Circuit Revision Change to the CoolRunner-II Family of CPLD Devices

PCN2004-24 (v1.2) August 19, 2005

Product/Process Change Notice - FYI

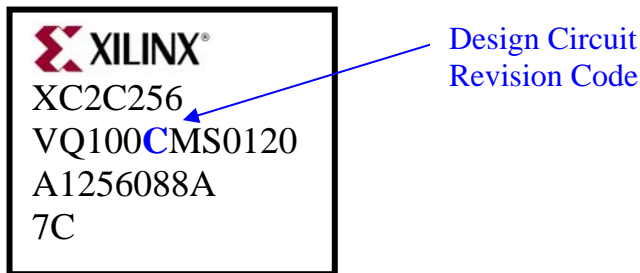
Traceability

The design circuit revision code on the package topmark can be found as shown below:
